## ORDINANCE 2010-004

**AN ORDINANCE APPROVING A PLANNED UNIT DEVELOPMENT (PUD) TO BE KNOWN AS SHERWOOD CANNERY SQUARE INCLUDING APPLICATION OF A PLANNED UNIT DEVELOPMENT OVERLAY ON THE COMPREHENSIVE PLAN AND ZONE MAP, APPROVING THE 10 LOT SUBDIVISION, APPROVING A TRANSPORTATION SYSTEM PLAN AMENDMENT TO CHANGE THE FUNCTIONAL CLASSIFICATION OF COLUMBIA FROM A COLLECTOR TO A LOCAL STREET, AND ESTABLISHING AN EFFECTIVE DATE**

- A. The transportation system plan is amended to include the Technical Memorandum listed as Exhibit N in the public record and attached to this Ordinance as Exhibit 2.
- B. The Planned Unit Development and subdivision is approved as described and conditioned in the Notice of Decision-Findings attached as Exhibit 1.
- C. The Plan and Zone Map shall be updated to reflect the approved PUD overlay applied to the parcels identified as Tax Map 2S132BD Tax Lot 150, 151, 200, 800 & 900

- Figure 5-1: Pedestrian Master Plan

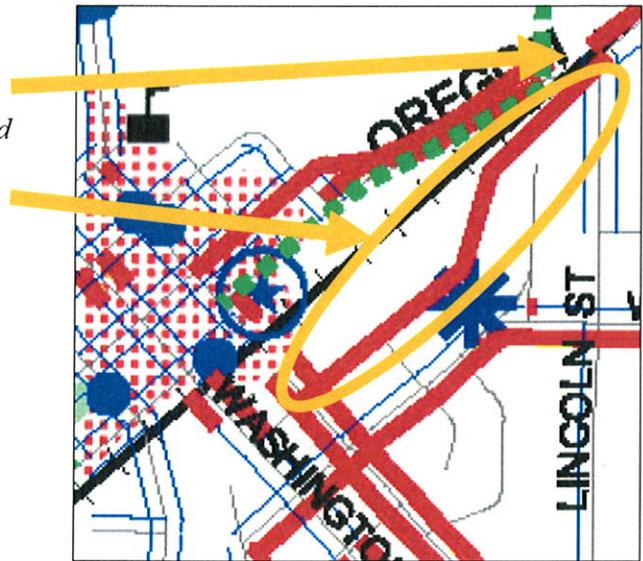
- Connect the planned Oregon Street sidewalks across the railroad
- Remove the Columbia Street-Oregon Street Extension sidewalks from the Action Plan

- Figure 6-1: Bicycle Master Plan

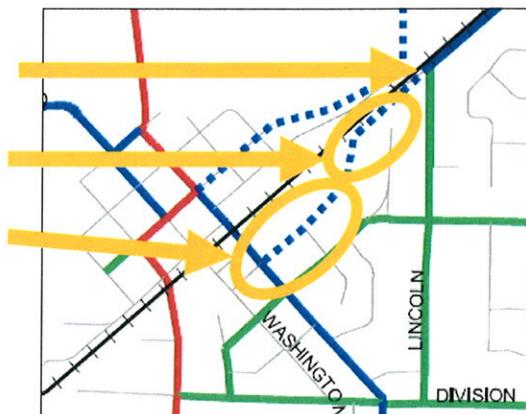
- Connect the planned Oregon Street bicycle facility across the railroad
- Remove the Columbia Street-Oregon Street Extension bicycle facility from the Master Plan

- Figure 8-7: Streets Where ROW is Planned for More Than Two Lanes

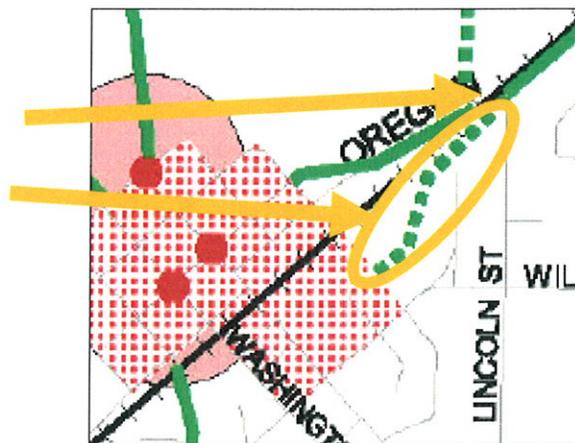
- Reconnect Oregon Street as a collector across the railroad
- Remove the Oregon Street Extension to Pine Street (via Columbia Street)

- Figure 8-8: Local Street Connectivity

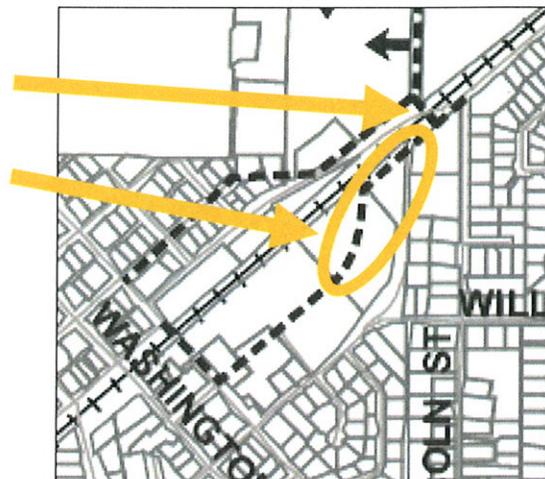
- Reconnect Oregon Street as a collector across the railroad
- Remove the Oregon Street Extension to Pine Street (via Columbia Street)
